To: Plan Holders for Improvements to the
KIRKSVILLE REGIONAL AIRPORT
KIRKSVILLE, MISSOURI
MODOT PROJECT NO. 24-028A-1

Transmitted herewith is Addendum **No. 4** to the Issued for Bid Contract Documents, Specifications and Plans dated May 30, 2024 for Improvements to the IRK Airport.

**ADDENDUM NO. 4
TO
CONTRACT DOCUMENTS, SPECIFICATIONS AND PLANS
FOR IMPROVEMENTS TO THE
KIRKSVILLE REGIONAL AIRPORT
KIRKSVILLE, MISSOURI
MODOT PROJECT NO. 24-028A-1**

STOREFRONT ELEVATIONS

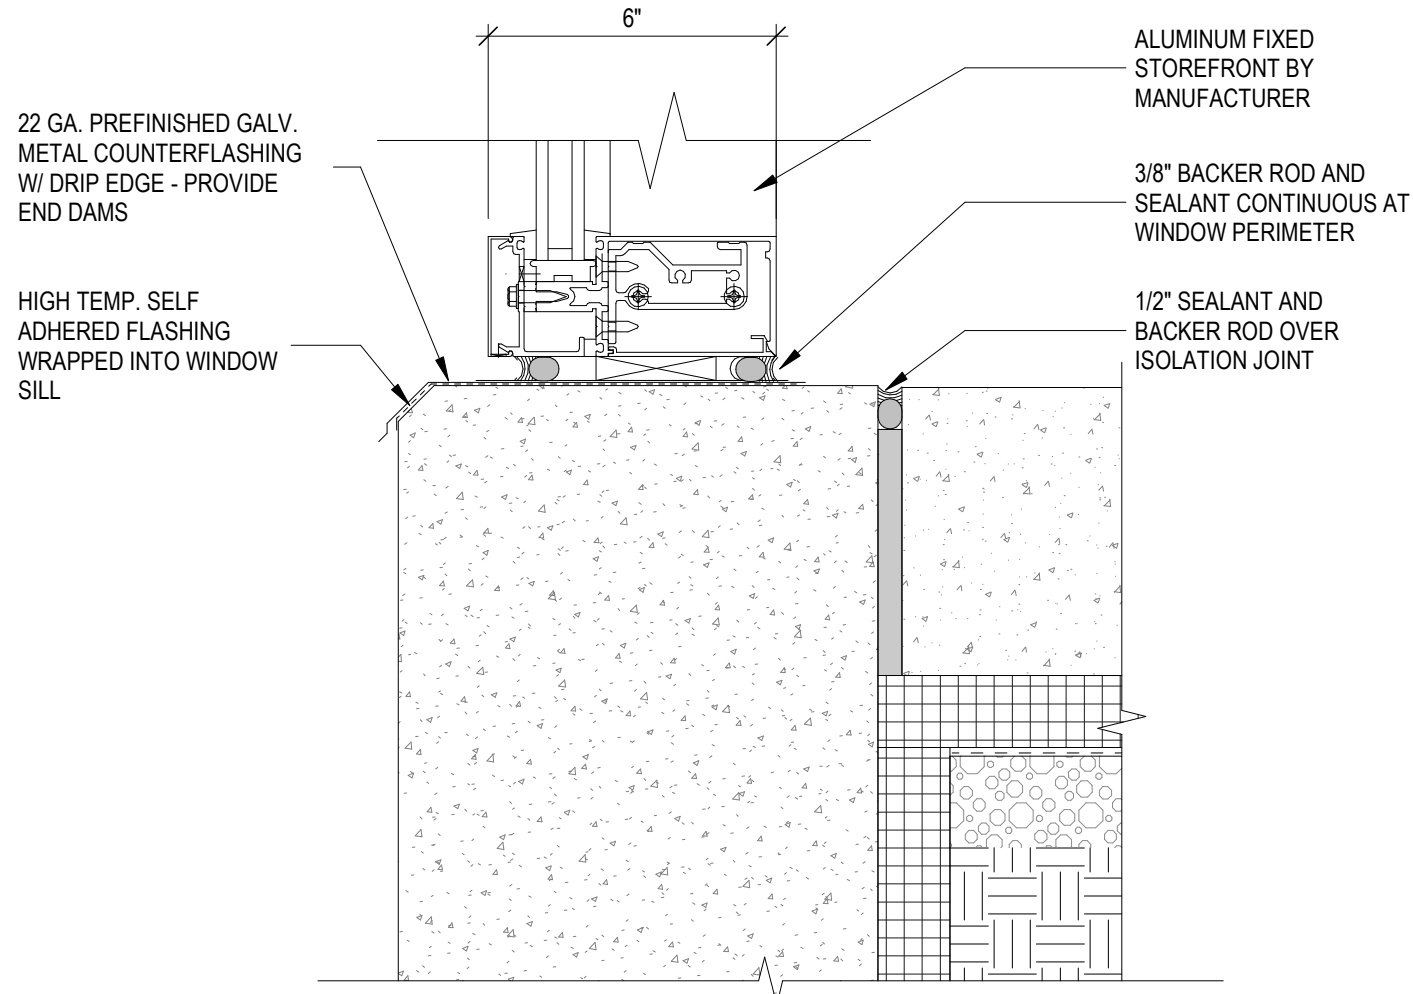
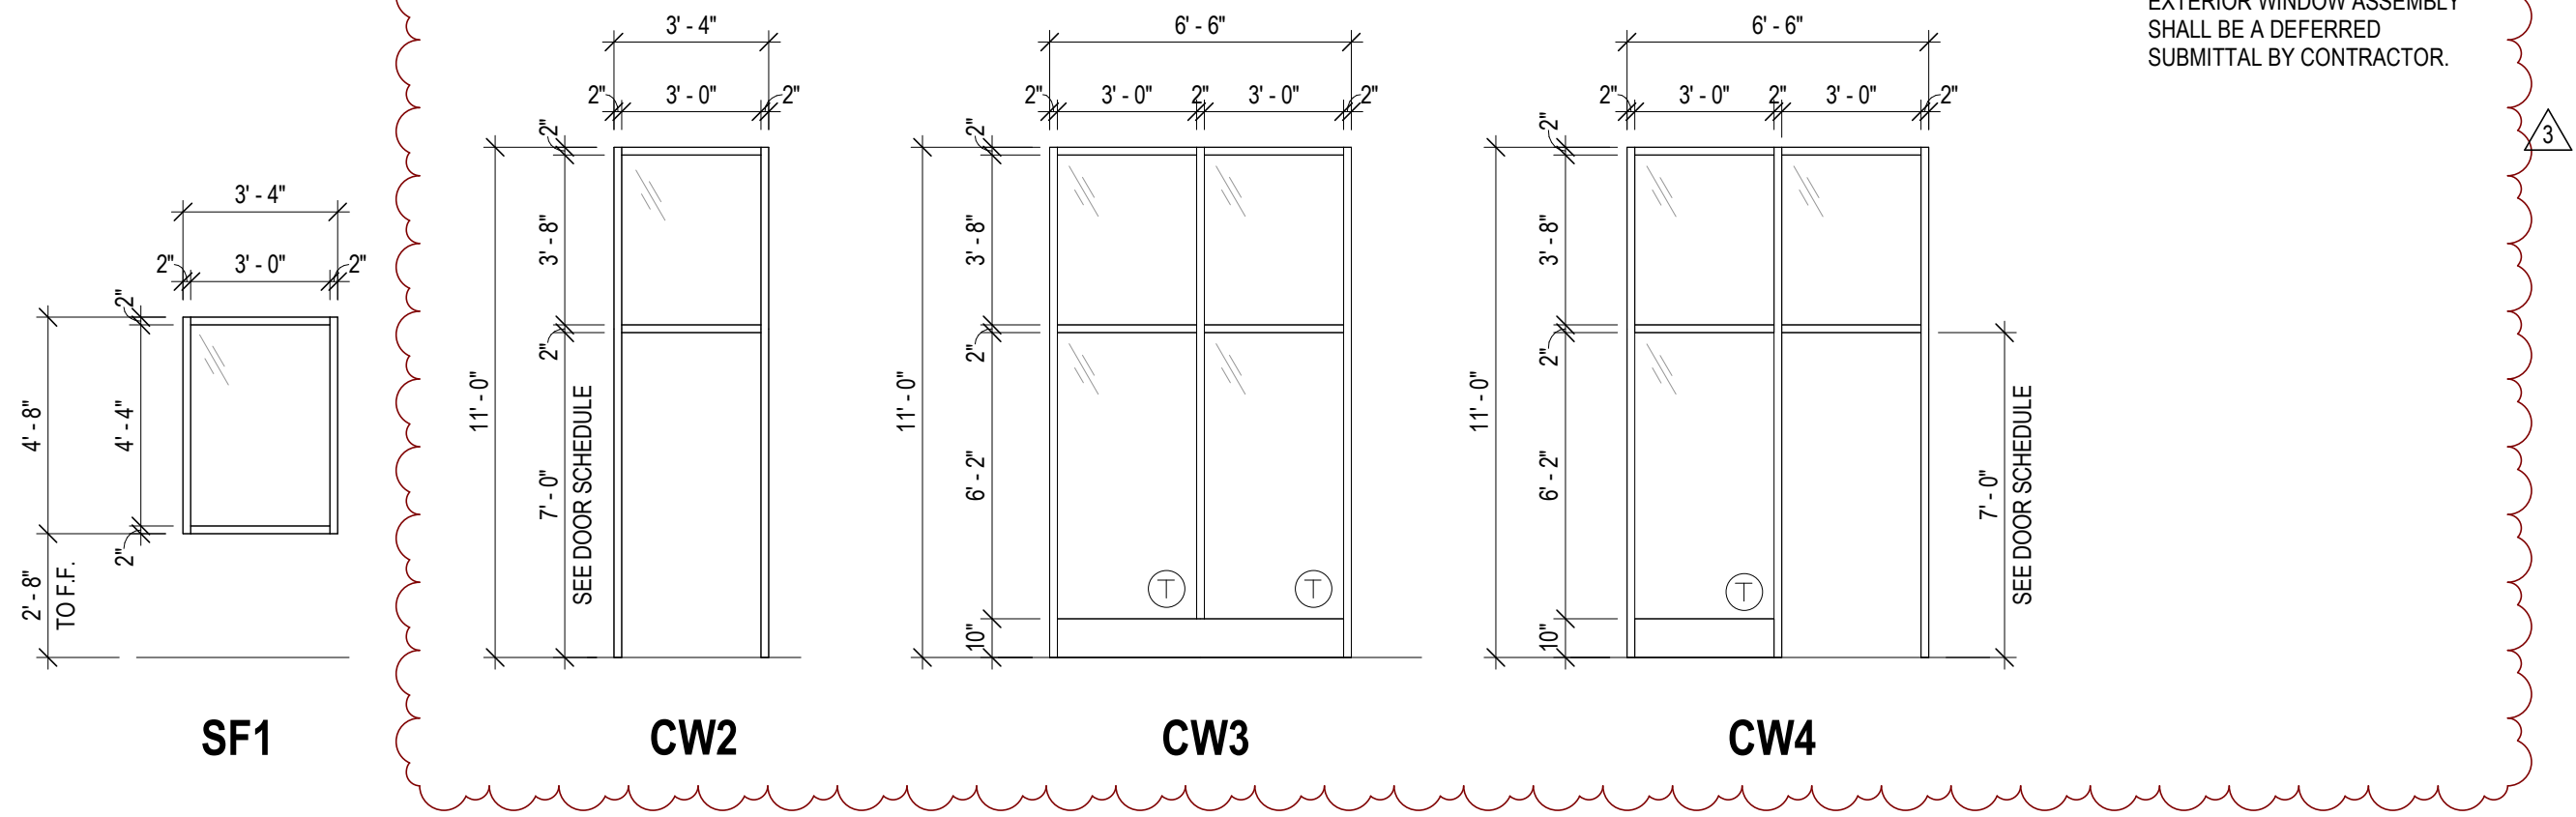
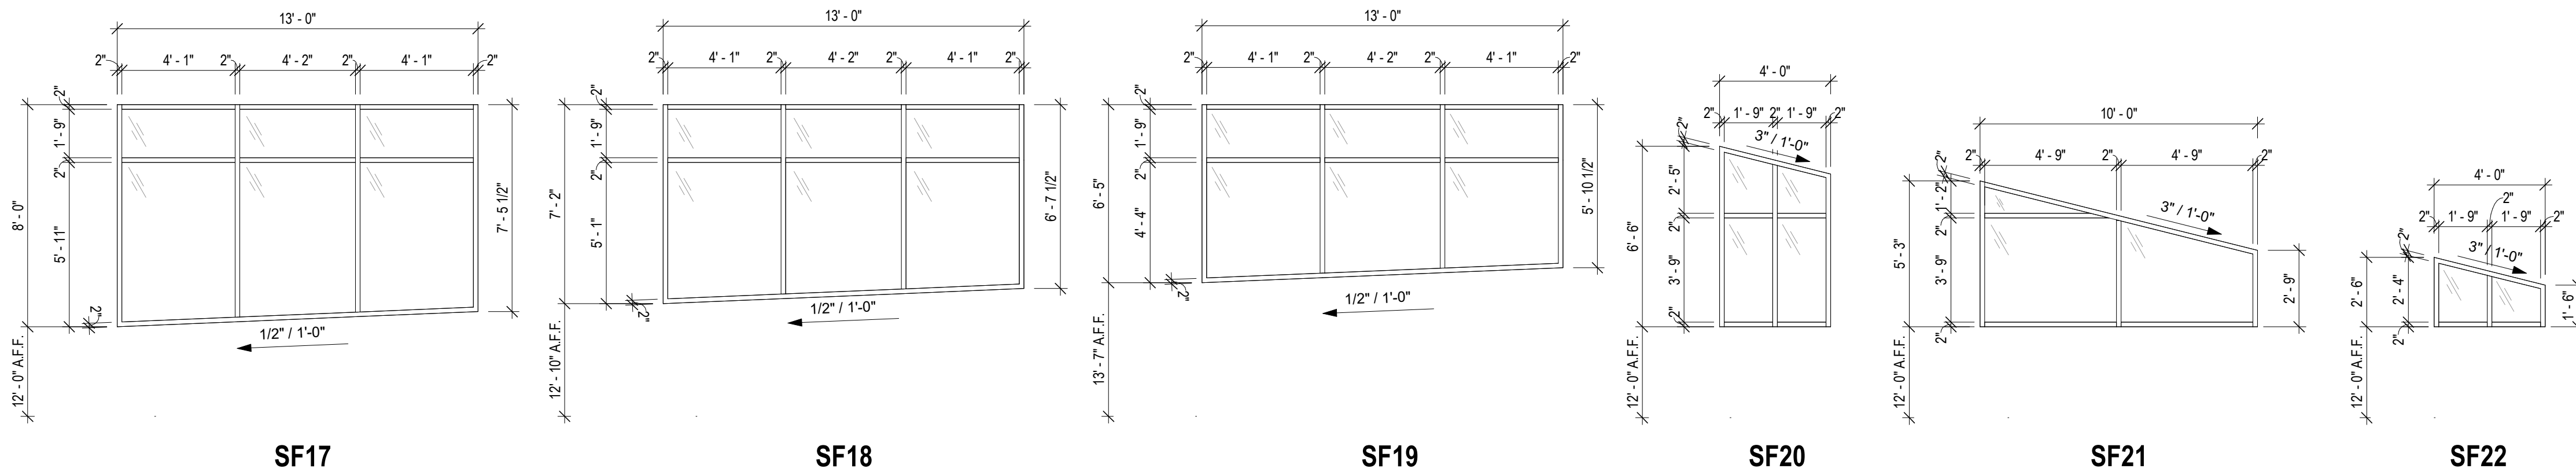
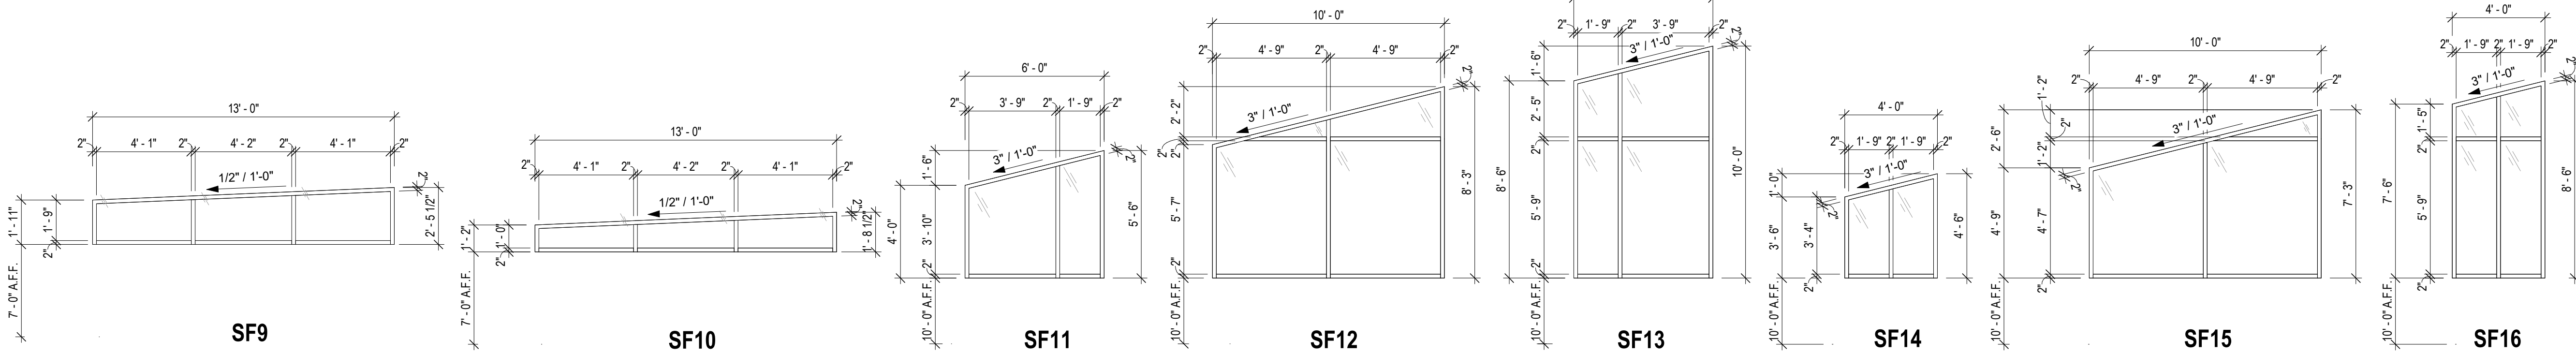
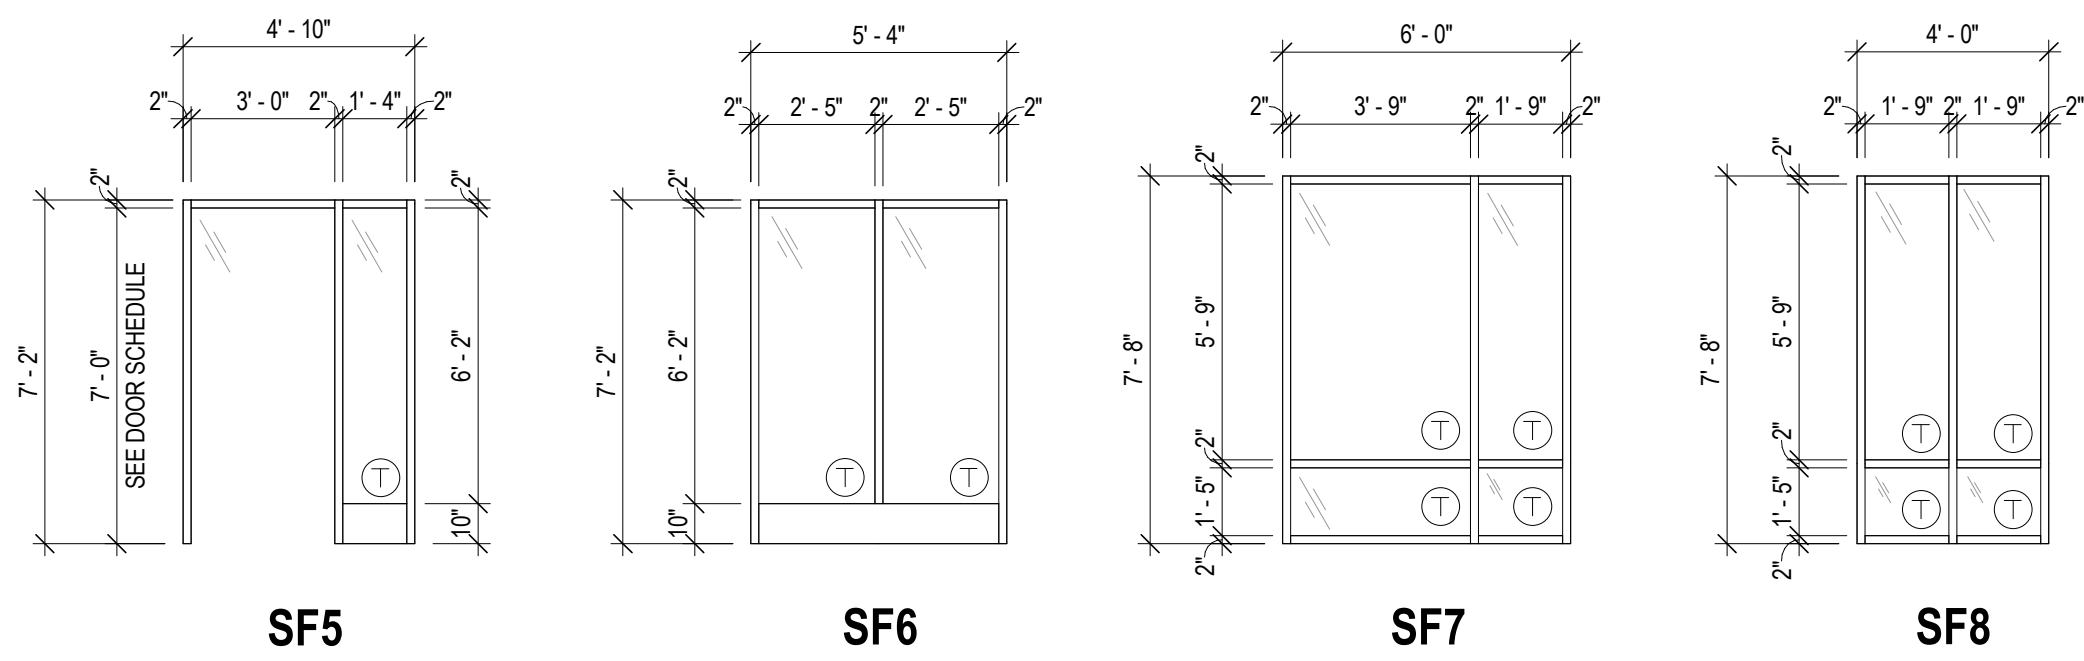
Sheet No.: A-621
Title: STOREFRONT SCHEDULE AND DETAILS
Revision: Curtain Wall Indication.
Justification: For clarity.

16. *Exterior is curtain wall, correct? Spec has curtain wall in it, and details show curtain wall, but on sheets it says storefront and shows 2" profiles. Curtain wall is 2 1/2" profile.*

Response: Refer to A-621. Windows in Hold Room exceed limit for storefront and shall be a deferred submittal for curtain wall system. Contractor to verify with storefront manufacture of sizes of storefront for acceptable warranty upon submittal.

PLUMBING PLAN

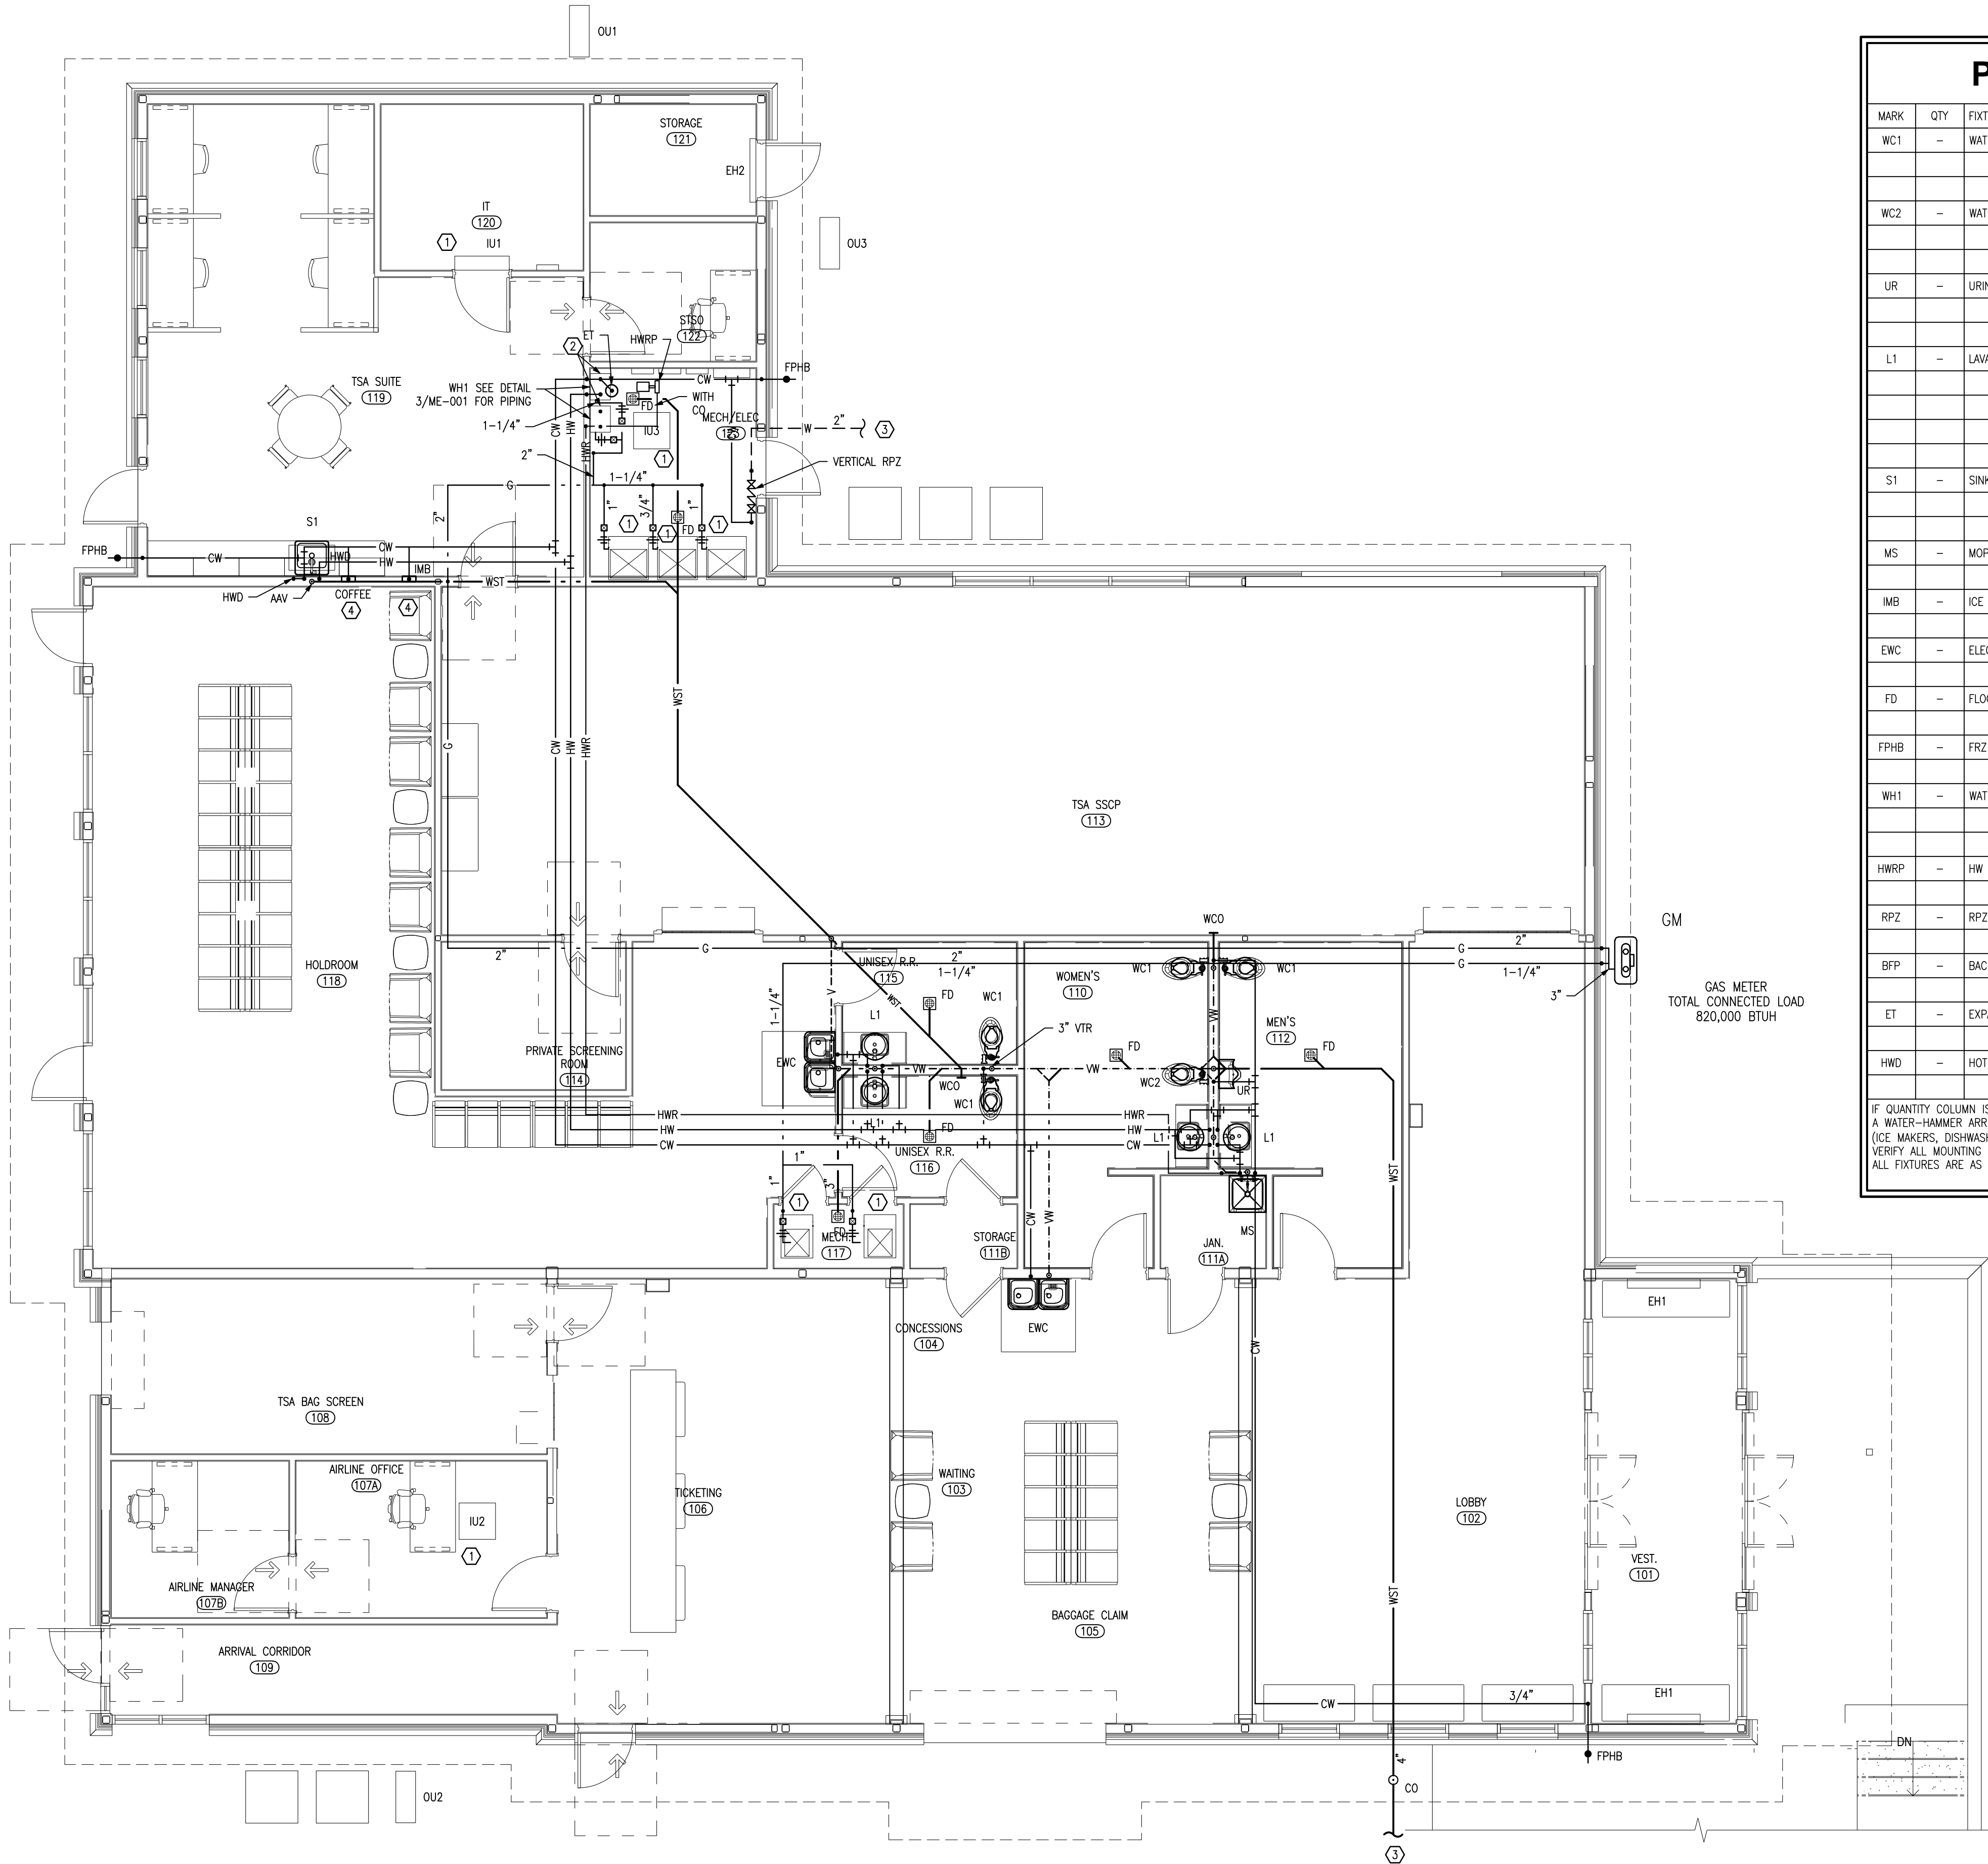
Sheet No.: P-101
Title: PLUMBING PLAN
Revision:
Justification: For clarity.
